**MEMORANDUM**

REVIEW TYPE: Special Exception and Variance Petition
APPLYING FOR: Child Daycare Facility
APPLICANT: Kids N Care Learning Center
CASE NUMBER: S-2471 and A-5641

REVIEW BASIS: Chapter 59, Zoning Ordinance
ZONE: R-200
LOCATION: Dawson Farm Road and Mateney Hill Road
MASTER PLAN: Germantown Master Plan
FILING DATE: February 9, 2001
PLANNING BOARD: September 13, 2001
PUBLIC HEARING: September 20, 2001 before the Hearing Examiner

DRAWING TITLE:
 SPECIAL EXCEPTION PLAN
 SITE PLAN
 LANDSCAPING PLAN

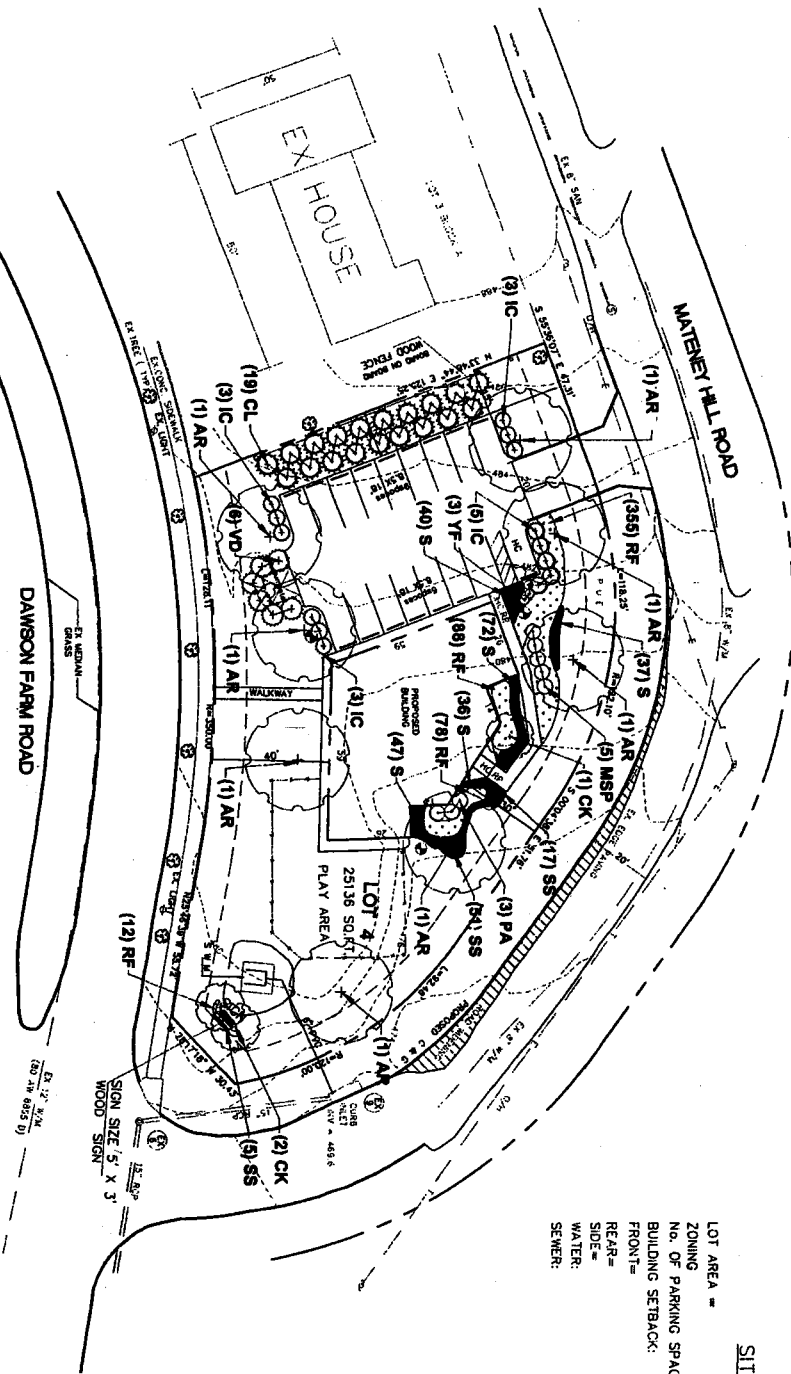
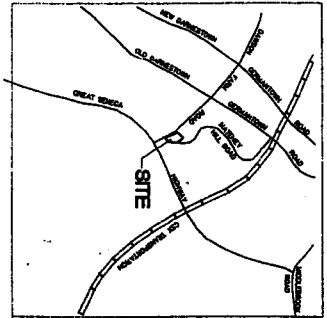
Staff has defined the building as having two fronts: Dawson Farm Road and Mateney Hill Road. The submitted site plan does not meet the development standards since the front yard setback from Mateney Hill Road is only 30 feet, instead of 40 feet as required by the zone. Additionally, the parking area does not meet the front yard setback standards for the residential zone. The site is large enough to meet the development standards for the zone, but the building's design and size of the parking facility does not allow it to conform to development standards. Subsequently, the applicant has applied for a variance for the building and parking area.

Staff recommends denial of the variances since the proposed use could be accommodated on the site without infringing upon the setbacks for the R-200 zone. The applicant’s building footprint could be reduced to a level where no variances are required. Although the site is narrow at its north-eastern end given the curvature of the road, staff is of the position that the application for a variance is a self-imposed hardship by the applicant and not necessarily the narrowness of the site. Staff further acknowledges that some properties along Mateney Hill Road are not consistent with the 40-foot setback requirement, including the adjacent property. As a new use, however, staff strongly believes that this use should be consistent with the development standards as established in the Zoning Ordinance.

Based on the submitted site plan and statement of operations, the applicant does meet the required number of parking spaces for a daycare facility. However, the applicant's revised site plan does not meet the front yard setback requirements, Section 59-E-2.81, for residential parking.

- a) Submit a final landscaping and lighting plan to M-NCPPC technical staff prior to the issuance of building permits that includes the following items:
 - i) The building must be setback 40 feet from Mateny Hill Road.
 - ii) Provide a wooden fence no higher than 6 feet with evergreen trees surrounding the garbage container.
 - iii) The height of the lighting poles must not exceed 10 feet.
